ADDENDUM NO. 2

PROJECT NO. PR 25-06-R LEGACY PARK IMPROVEMENTS

ADDENDUM NO. 2
TO
PROJECT NO. PR 25-06-R
LEGACY PARK IMPROVEMENTS

**ADDENDUM NUMBER TWO
TO
CONTRACT DOCUMENTS AND SPECIFICATIONS
FOR
INVITATION TO PROJECT NO. PR 25-6-R
LEGACY PARK IMPROVEMENTS**

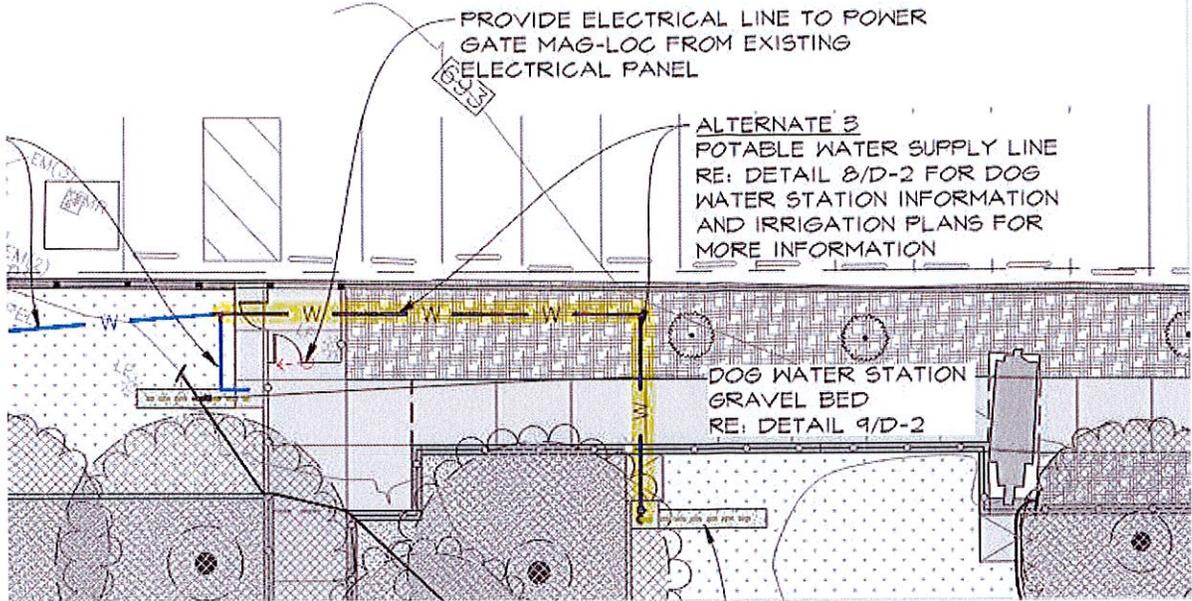
3. SMALL DOG PARK WATER STATION PLUMBING QUESTION:

Submitted Question:

The small dog water station is an alternate. Is the plumbing to it also an alternate or is it to be ran regardless?

Answer:

The section of plumbing running to the small dog park water station will be included as an alternate. This section of plumbing is highlighted in yellow below:
